REQUEST FOR INFORMATION **DATE:** July 22, 2016 **NO.:** RFI-214 **REV 1**

Project Name: 15051-Webster University Interdisciplinary Science Building Project No.: 15051

Subject: Fall Protection Design

LEVEL 05 ROOF FRAMING PLAN

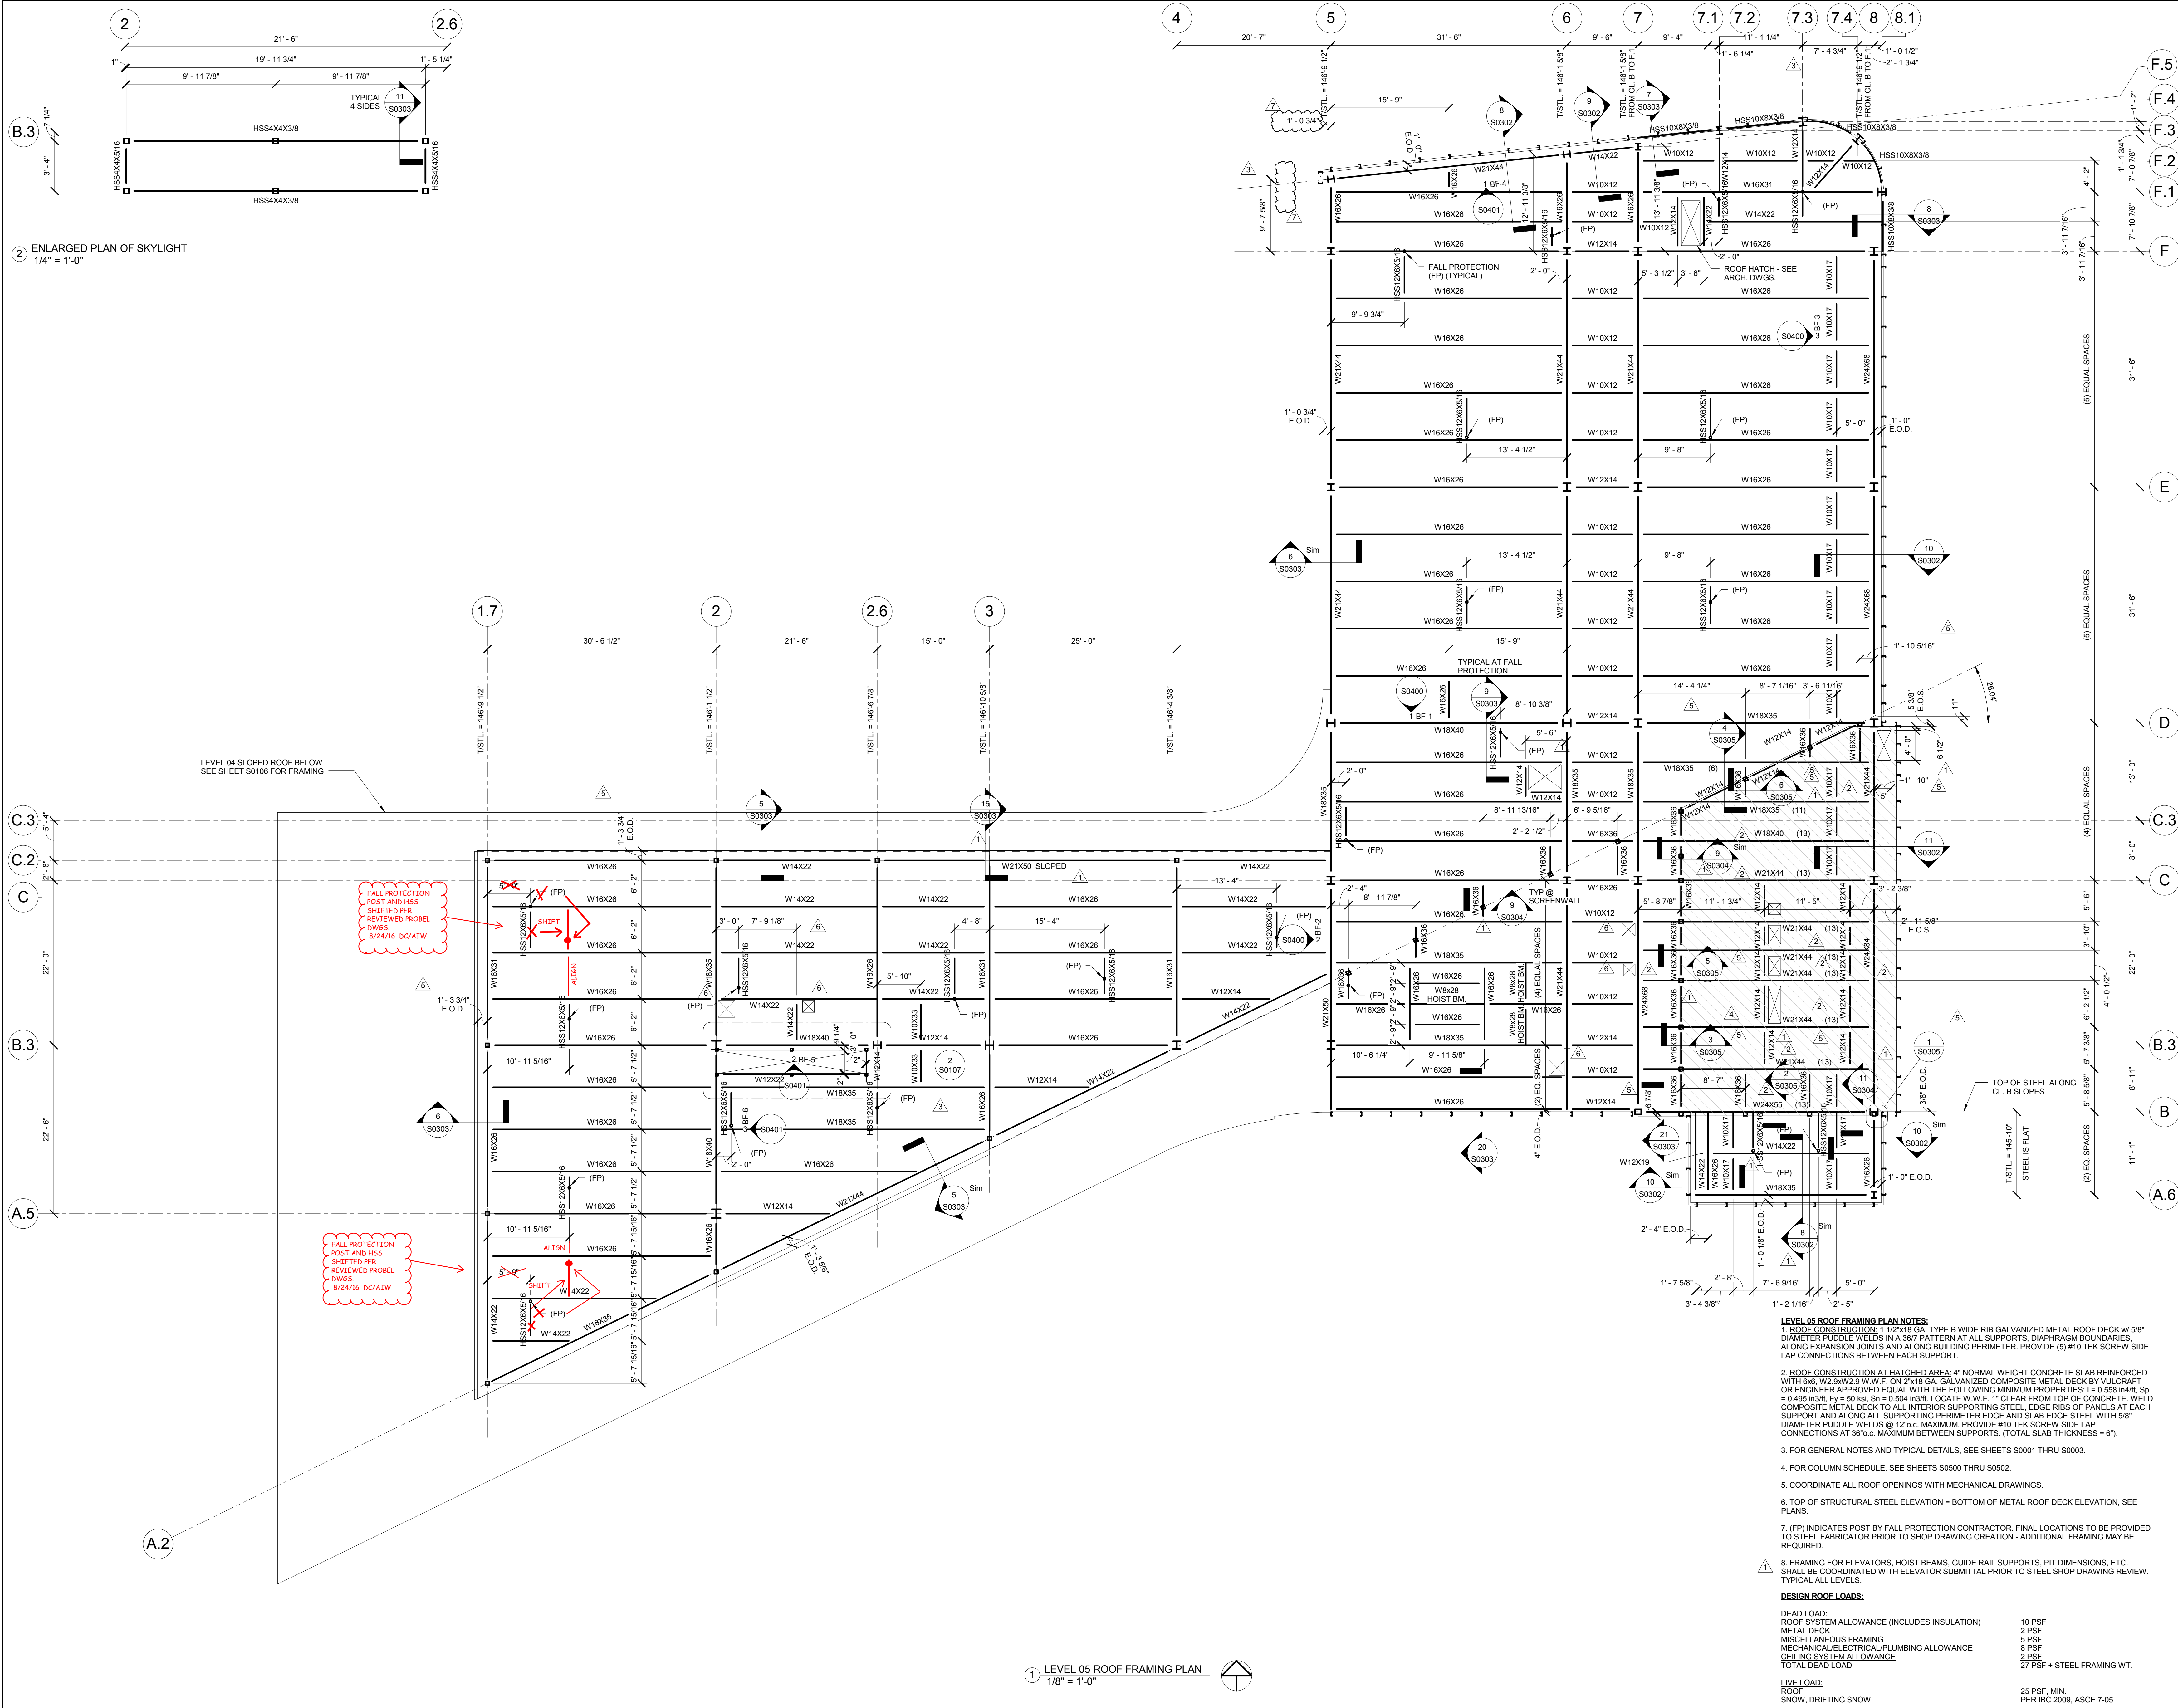
Probel originally submitted their drawings based on the architectural layout, and used that layout to indicate which two anchors they wanted/needed to relocate so that they could take responsibility of the fall protection system. Since this would require relocating the 12x6 tubes the anchors are attached to; Atlas feels the design team should review and approve the change. If this is an acceptable change, then Atlas expects Probel to re-issue drawings for approval based on the structural layout (per RFI 188), adding the (3) anchors and the +/-25' of cable.

Response: PROBEL'S FALL PROTECTION DESIGN REQUIRES RELOCATING TWO FP POSTS - REVISED LOCATIONS ARE ACCEPTABLE FOR ROOF FRAMING.

WE HAVE NOT RECEIVED ANY DRAWINGS FOR CONFLICT REVIEW FOR THE DELEGATED DESIGN OF FALL PROTECTION SYSTEM BY PROBEL.
